SUBMITTAL OF HANFORD FACILITY RESOURCE CONSERVATION AND RECOVERY
ACT (RCRA) PERMIT MODIFICATION NOTIFICATION FORM 24590-PTF-PCN-ENV-06-
018

Permit Modification Notification Form 24590-PTF-PCN-ENV-06-018 updates the Mechanical Data Sheets for the PTF Waste Feed Vessels (24590-PTF-MV-FRP-VSL-00002A/B/C/D) found in Appendix 8.6 of the Reference.

24590-PTF-PCN-ENV-06-018

Page 2 of 3: Hanford Facility RCRA Permit, Operating Unit 10, Waste Treatment and Immobilization Plant
Update Mechanical Data Sheets for Pretreatment Facility Waste Feed Receipt Vessels (24590-PTF-MV-FRP-VSL-00002A/B/C/D) in Appendix 8.6 of the Dangerous Waste Permit.

PLANT ITEM No.
24590-PTF-MV-FRP-VSL-00002A

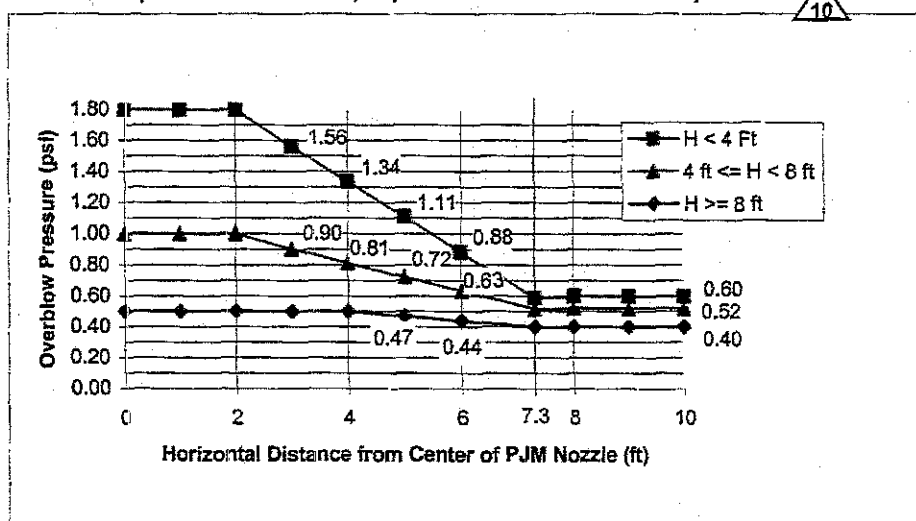
- Note 12:** Revision 10 of this data sheet incorporates the CCN 129149. The CCN added the words "in the form of overblow pressures", to the note shown above the overblow loads graph and further revised the note below the graph, as noted herein on sheet 3 of 5. Added calculation 24590-PTF-MTC-FRP-00001 and Environmental Qualification on Sheet 1. Added the note identified by ** on sheet 1.

Overflow loads vary as a function of the distance from the center of the overflowing pulse jet mixer nozzle and the elevation 'H' above the overflowing pulse jet mixer nozzle up to the overflow level, as plotted in the form of overflow pressures:

For all vessel internal components other than the overflowing pulse jet mixer, the overflow forces shall be applied a) in the vertical direction, and b) in the horizontal direction, radiating from the centerline of the overflowing pulse jet mixer. For the overflowing pulse jet mixer, the force shall be applied in the vertical upward direction only. The overflow force on all components, including the structures and supports, shall be calculated by applying the overflow pressure at the location of the nearest surface of the component and to the projected area of the component, facing the appropriate direction. The normal force component, specified for the normal pulse jet mixer operation condition, is not applicable to the overflow condition. Any single pulse jet mixer may overflow 1000 cycles. Reference CCN 125541 dated 07/27/05.

PLANT ITEM No.
24590-PTF-MV-FRP-VSL-00002B

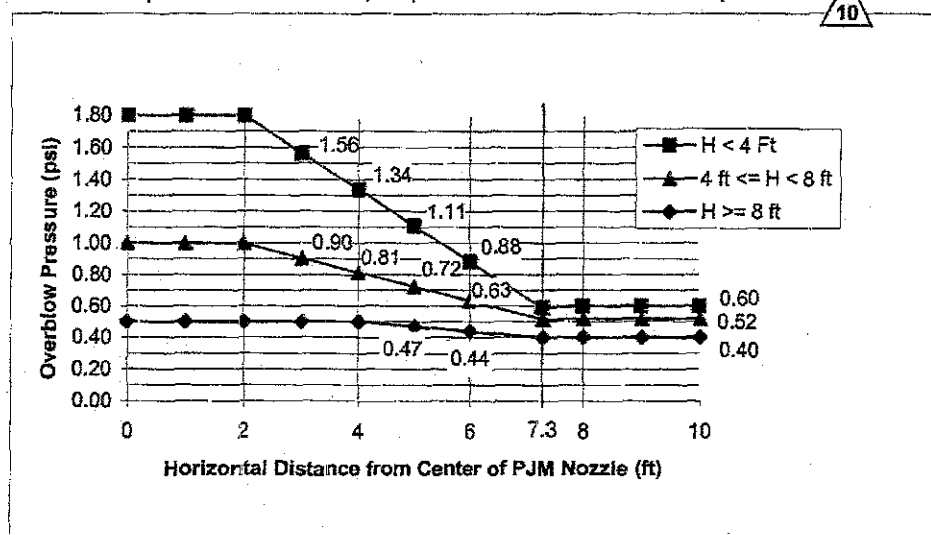
- Note 12:** Revision 10 of this data sheet incorporates the CCN 129149. The CCN added the words "in the form of overblow pressures", to the note shown above the overblow loads graph and further revised the note below the graph, as noted herein on sheet 3 of 5. Added calculation 24590-PTF-MTC-FRP-00001 and Environmental Qualification on Sheet 1. Added the note identified by ** on sheet 1.

Overflow loads vary as a function of the distance from the center of the overflowing pulse jet mixer nozzle and the elevation 'H' above the overflowing pulse jet mixer nozzle up to the overflow level, as plotted in the form of overflow pressures:

For all vessel internal components other than the overflowing pulse jet mixer, the overflow forces shall be applied a) in the vertical direction, and b) in the horizontal direction, radiating from the centerline of the overflowing pulse jet mixer. For the overflowing pulse jet mixer, the force shall be applied in the vertical upward direction only. The overflow force on all components, including the structures and supports, shall be calculated by applying the overflow pressure at the location of the nearest surface of the component and to the projected area of the component, facing the appropriate direction. The normal force component, specified for the normal pulse jet mixer operation condition, is not applicable to the overflow condition. Any single pulse jet mixer may overflow 1000 cycles. Reference CCN 125541 dated 07/27/05.

PLANT ITEM No.
24590-PTF-MV-FRP-VSL-00002C

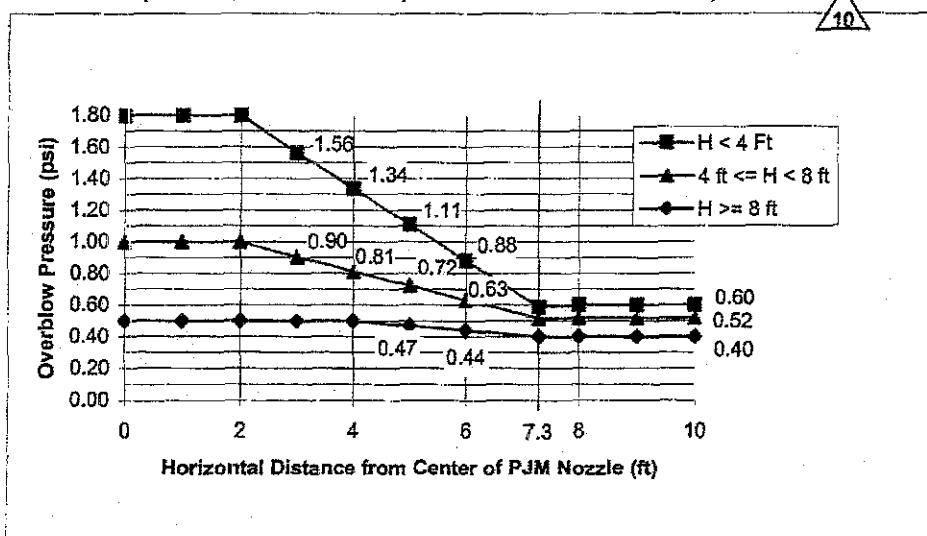
- Note 12:** Revision 10 of this data sheet incorporates the CCN 129149. The CCN added the words "in the form of overblow pressures", to the note shown above the overblow loads graph and further revised the note below the graph, as noted herein on sheet 3 of 5.

Overblow loads vary as a function of the distance from the center of the overblowing pulse jet mixer nozzle and the elevation 'H' above the overblowing pulse jet mixer nozzle up to the overflow level as plotted in the form of overblow pressures:

For all vessel internal components other than the overblowing pulse jet mixer, the overblow forces shall be applied a) in the vertical direction, and b) in the horizontal direction, radiating from the centerline of the overblowing pulse jet mixer. For the overblowing pulse jet mixer, the force shall be applied in the vertical upward direction only. The overblow force on all components, including the structures and supports, shall be calculated by applying the overblow pressure at the location of the nearest surface of the component and to the projected area of the component, facing the appropriate direction. The normal force component, specified for the normal pulse jet mixer operation condition, is not applicable to the overblow condition. Any single pulse jet mixer may overblow 1000 cycles. Reference CCN 125541 dated 07/27/05.

PLANT ITEM No.
24590-PTF-MV-FRP-VSL-00002D

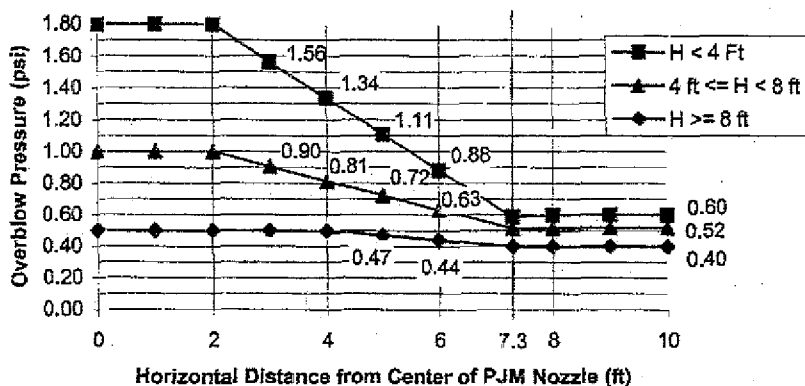
- Note 12:** Revision 10 of this data sheet incorporates the CCN 129149. The CCN added the words "in the form of overblow pressures", to the note shown above the overblow loads graph and further revised the note below the graph, as noted herein on sheet 3 of 5. Added calculation 24590-PTF-MTC-FRP-00001 and Environmental Qualification on Sheet 1. Added the note identified by ** on sheet 1.

Overblow loads vary as a function of the distance from the center of the overblowing pulse jet mixer nozzle and the elevation 'H' above the overblowing pulse jet mixer nozzle up to the overflow level, as plotted in the form of overblow pressures:

For all vessel internal components other than the overblowing pulse jet mixer, the overblow forces shall be applied a) in the vertical direction, and b) in the horizontal direction, radiating from the centerline of the overblowing pulse jet mixer. For the overblowing pulse jet mixer, the force shall be applied in the vertical upward direction only. The overblow force on all components, including the structures and supports, shall be calculated by applying the overblow pressure at the location of the nearest surface of the component and to the projected area of the component, facing the appropriate direction. The normal force component, specified for the normal pulse jet mixer operation condition, is not applicable to the overblow condition. Any single pulse jet mixer may overblow 1000 cycles. Reference CCN 125541 dated 07/27/05.
